# Water Leak At Back Door Hatch

YEAR(S)	MODEL(S)	ADDITIONAL INFORMATION
2004 – 2009	RX330, RX350, RX400H

### TSB REVISION NOTICE

March 10, 2009 Rev1:

Figure 2.

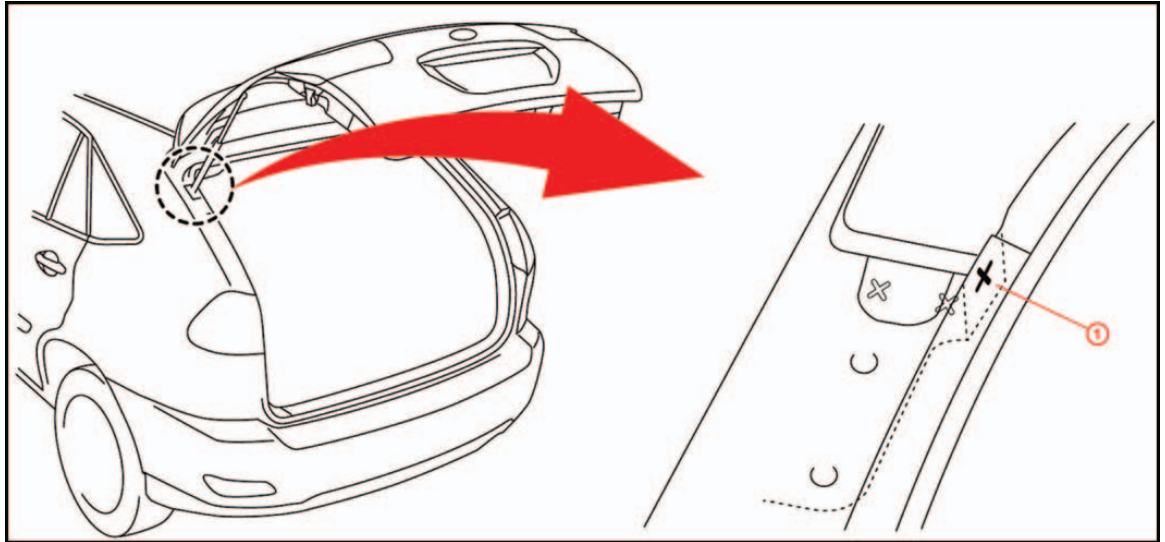
- A. Record radio presets.
- B. Add a spot weld to the location as illustrated below to left and right strut area (Left side shown for reference).

1 Spot weld location

Figure 3. Left side shown for reference

1 Spot Weld Location

5. Apply seam sealer to the weld location and repaint the rear hatch area according to the paint manufacturer's recommendations.
6. Confirm leak is eliminated by water testing.
7. Connect battery and reinitialize the moon roof and reset radio as necessary. Refer to TSIB [L-SB-0003-08](#): "Initialization of Power Back Door During PDS".
